Additional Traffic and Access Report

18 October, 2013

**RE: PART 3A APPLICATIONS FOR PROPOSED NEPEAN GREEN AND
MASTERS MIXED USE DEVELOPMENT, 164 STATION STREET, PENRITH**

**Existing weekday afternoon peak hour
traffic flows plus development traffic**

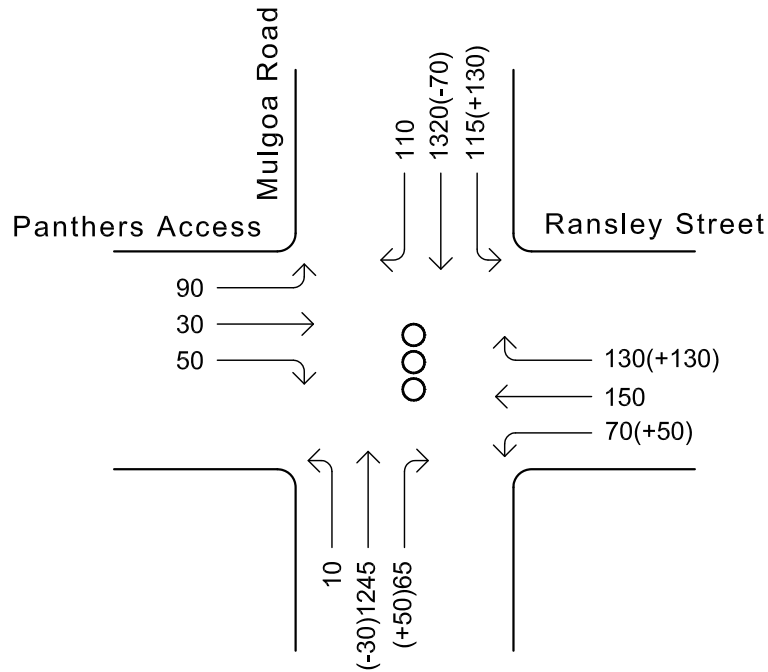
- a) *Intersection of Ransley Street and Mulgoa Road*
Ransley Street will become a major access point into the development, with the most direct access to Mulgoa Road. Intersection analysis of current and future conditions at the Ransley Street and Mulgoa Road intersection needs to be undertaken. Details of any required mitigation measures should also be considered and identified.
3. We have undertaken traffic counts at the intersection of Mulgoa Road with Ransley Street/Panthers access during weekday afternoon and Saturday peak periods. The results of the surveys are attached to this letter as Figures 1 and 2, and summarised in Table 1.

9. The additional development traffic through the Mulgoa Road/Ransley Street intersection is also shown in Figures 1 and 2, and summarised in Table 2 below.

10. Table 2 shows that with the proposed development, traffic increases on Ransley Street would be some 170 to 360 vehicles per hour two-way at peak times. Increases on Mulgoa Road would be lower at some 40 to 260 vehicles per hour two-way.
11. The intersection has been re-analysed with SIDRA for the additional development traffic flows shown in Figures 1 and 2. The analysis found that the intersection would operate with average delays of less than 35 seconds per vehicle during peak periods. This represents level of service C, a satisfactory level of service.
12. Therefore, the intersection will be able to cater for the additional traffic from the proposed development.

Traffic flows at intersections of new internal access road with Station Street and Woodriff Street

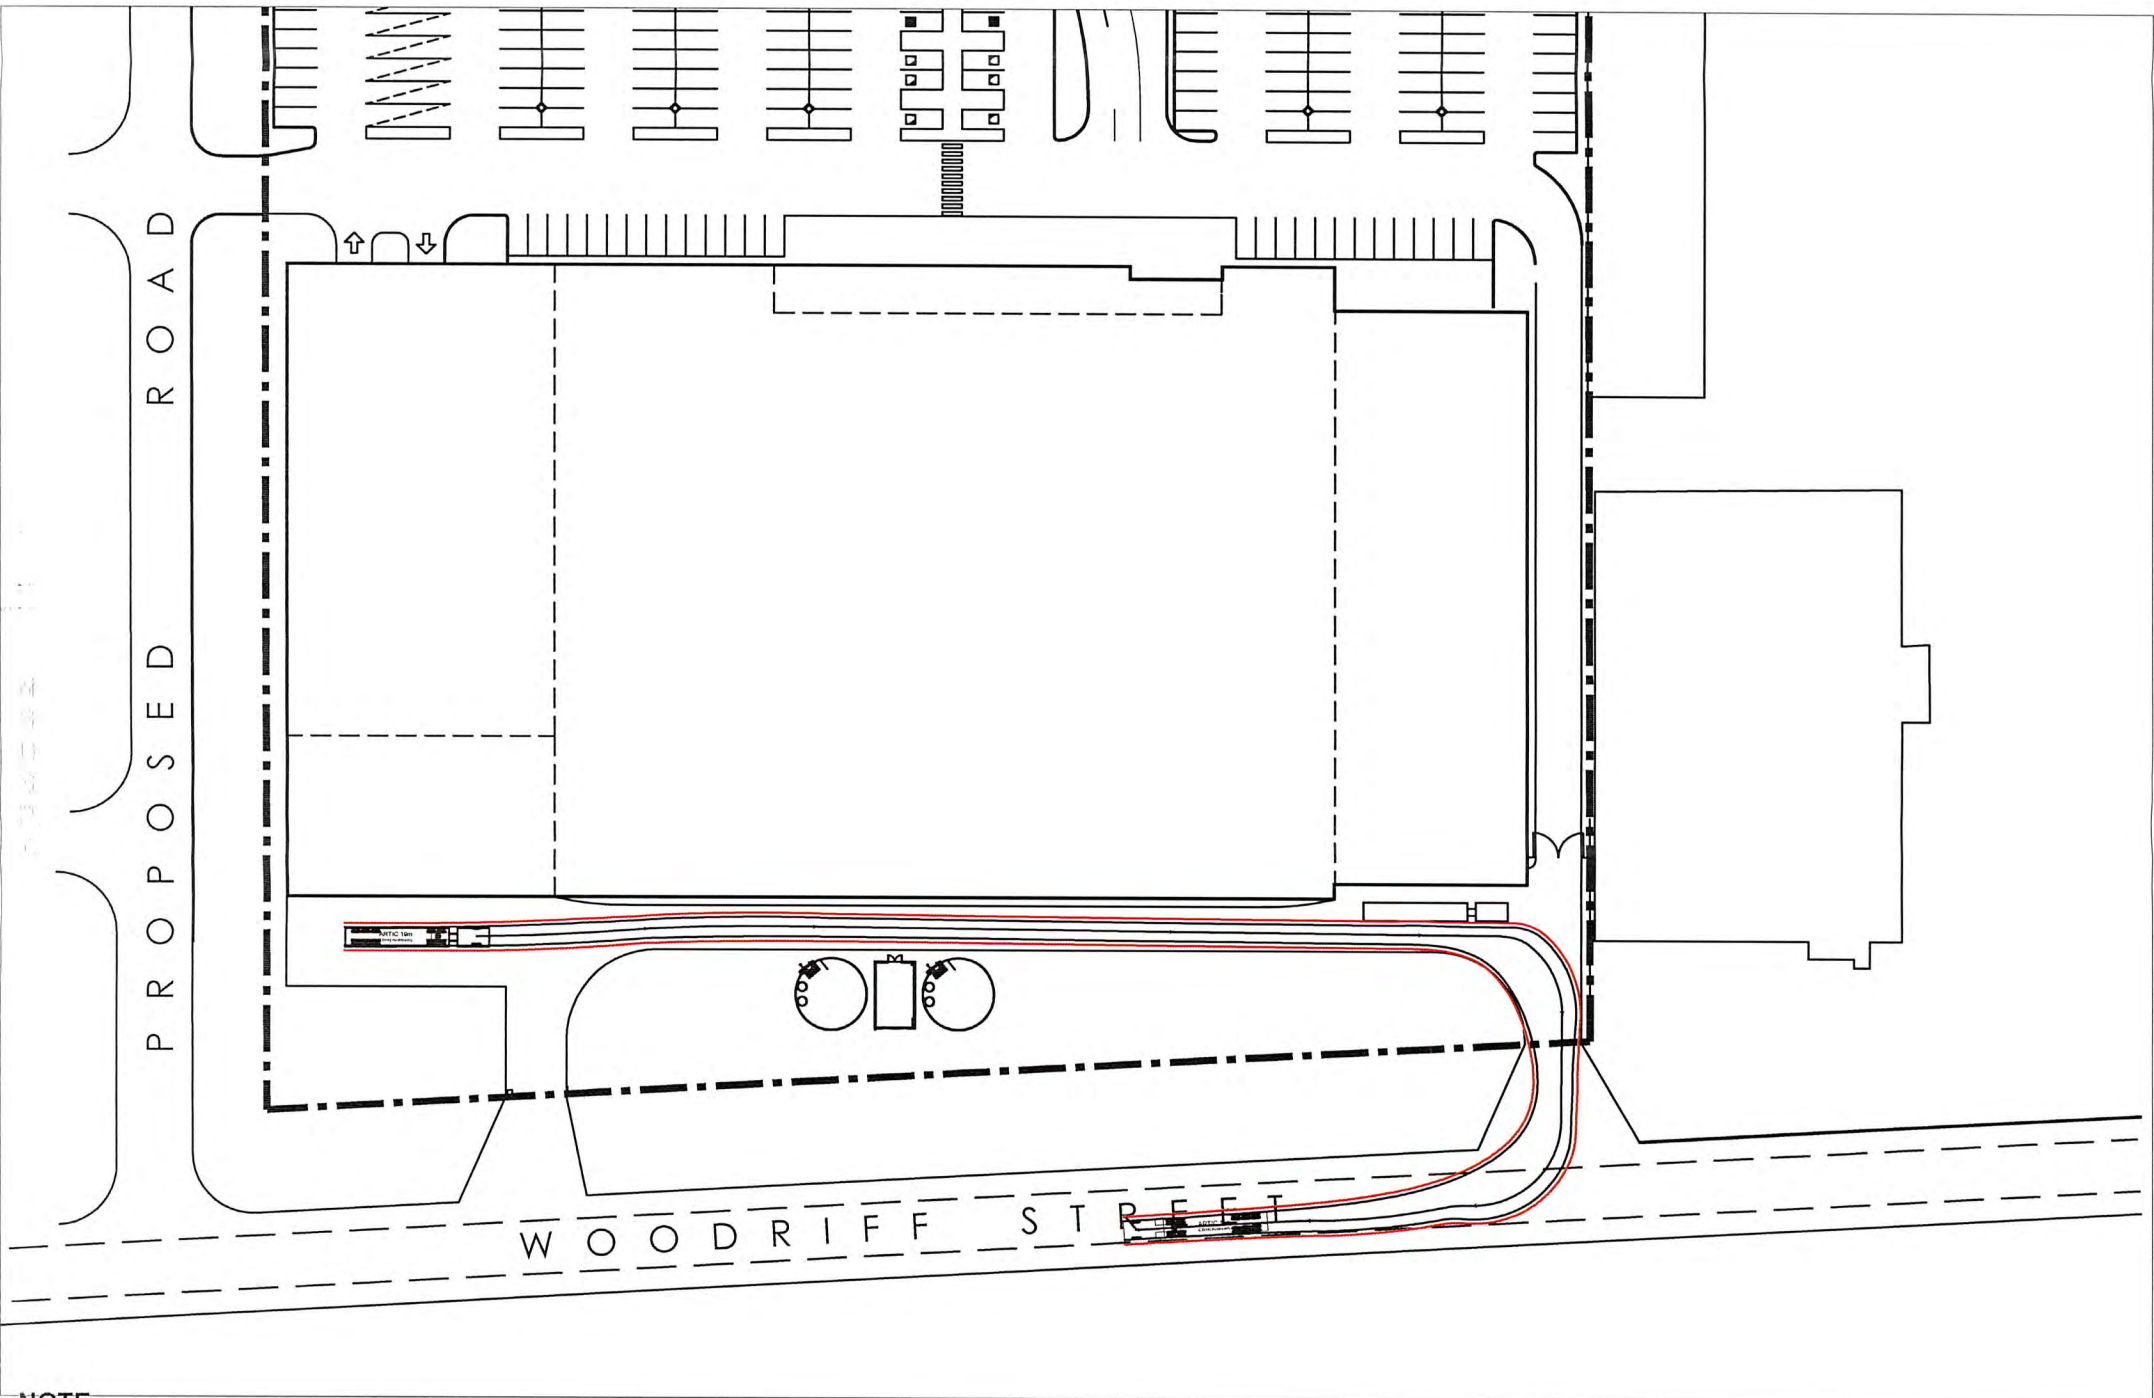
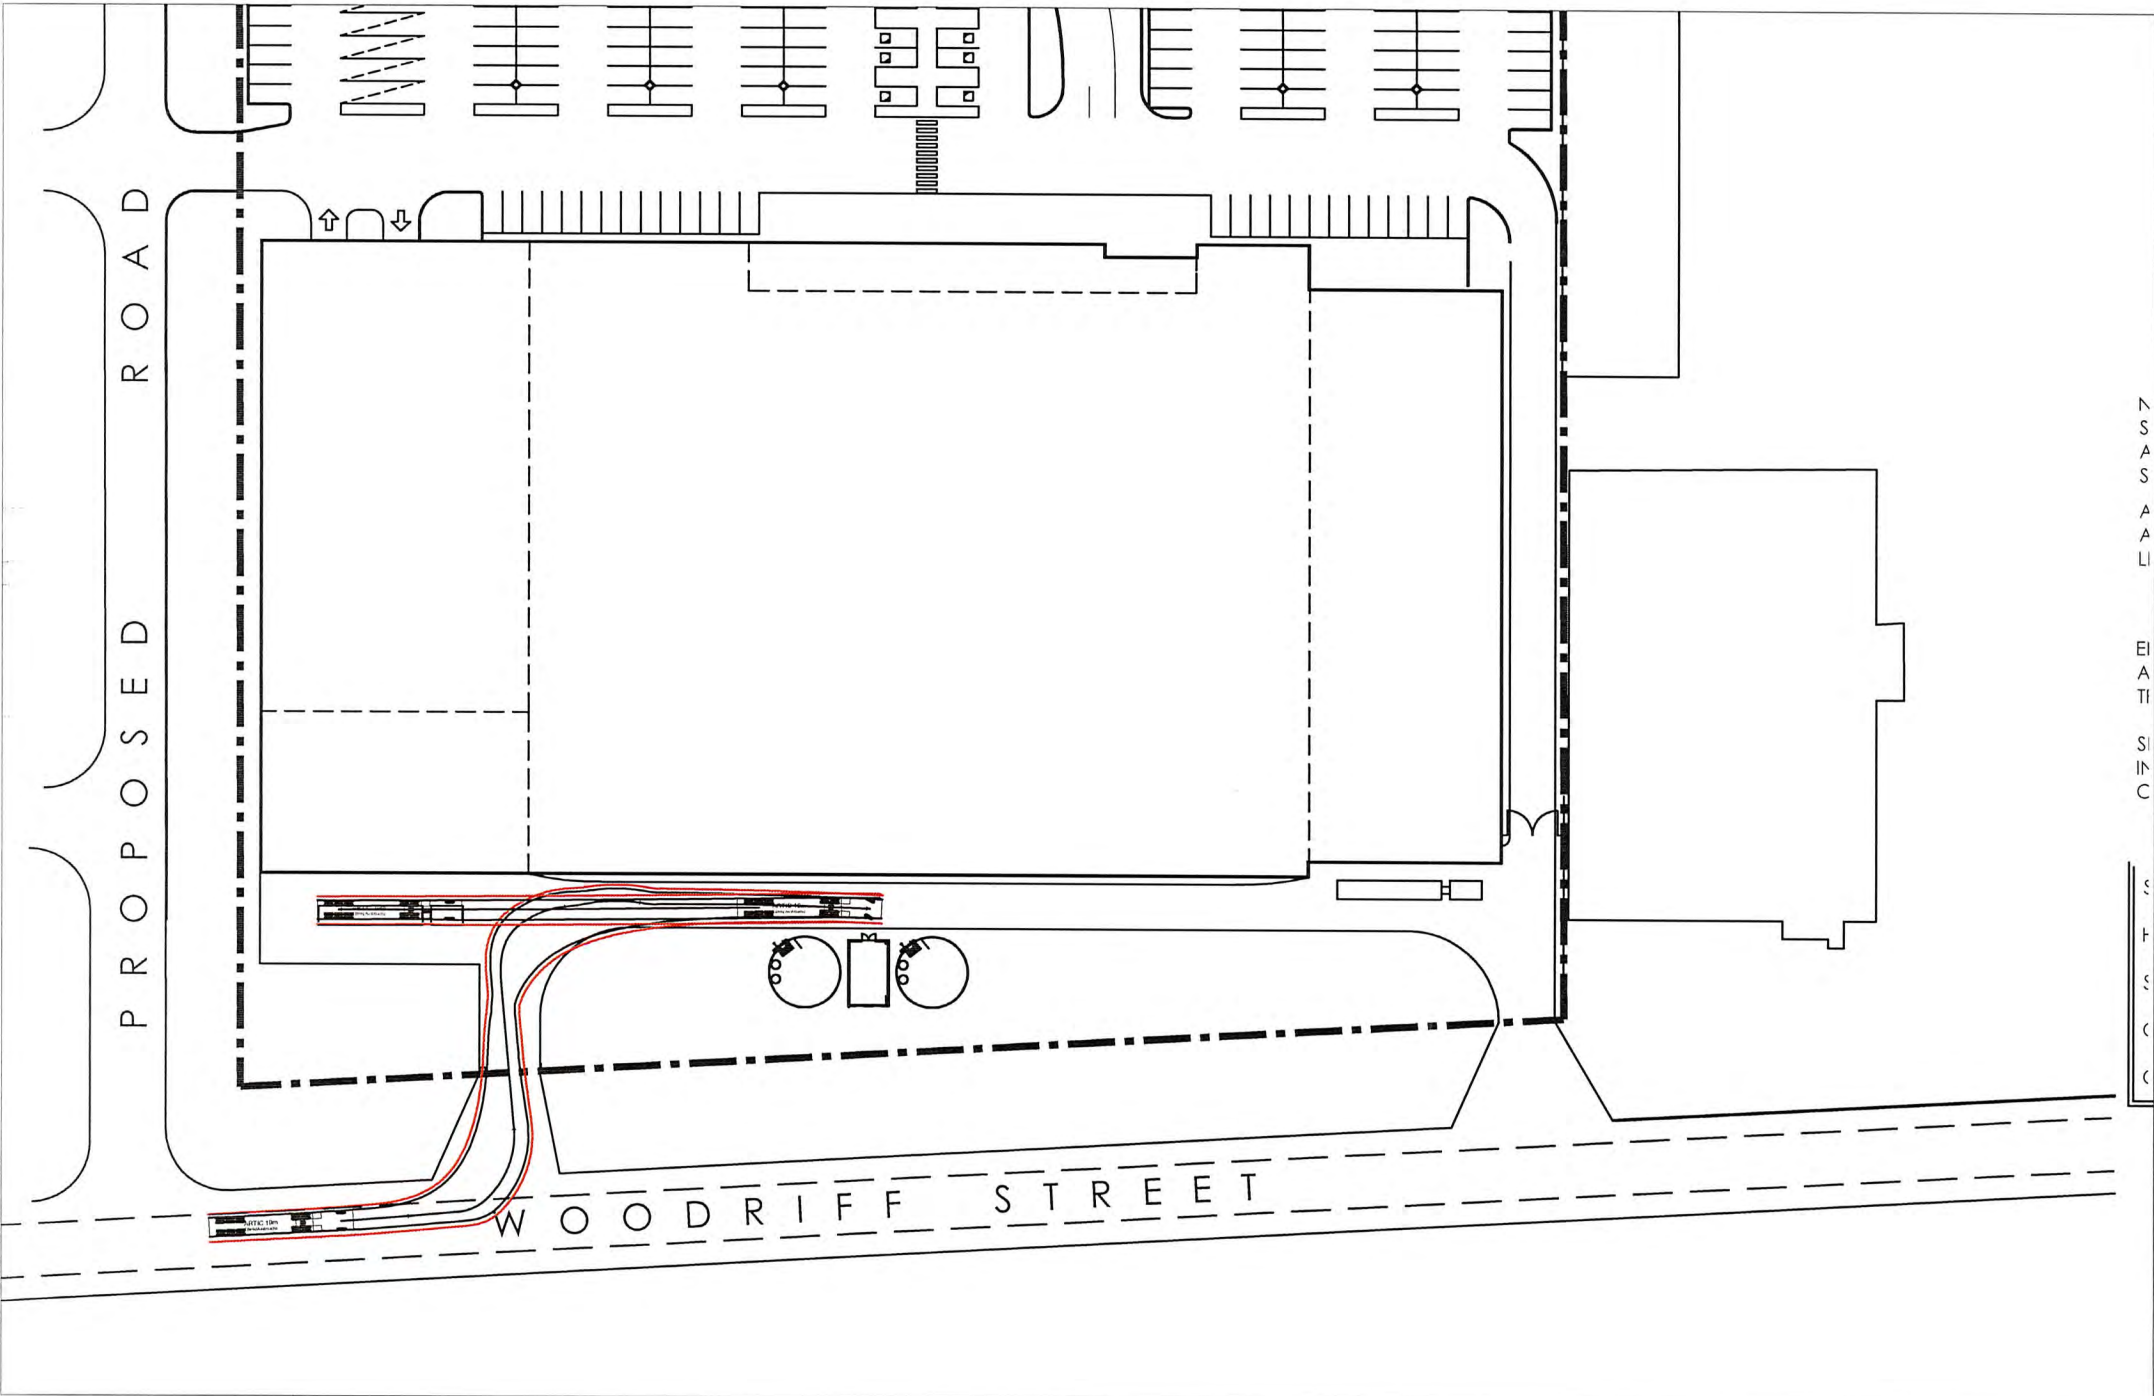
While trips along the road network have been shown in Table 3.1 of the Colston Budd report, further details of trip distribution to and from each site access point are required; to clarify along which sections of the road network the traffic generated by the project is travelling.

26. Traffic turning to and from the proposed Masters access point is shown in Figures 2 and 3 of our previous report. Traffic flows at the intersections of the new internal road with Station Street and Woodriff Street are shown in Figure 3 attached to this letter, and included in the SIDRA analysis previously provided to DoP/RMS.
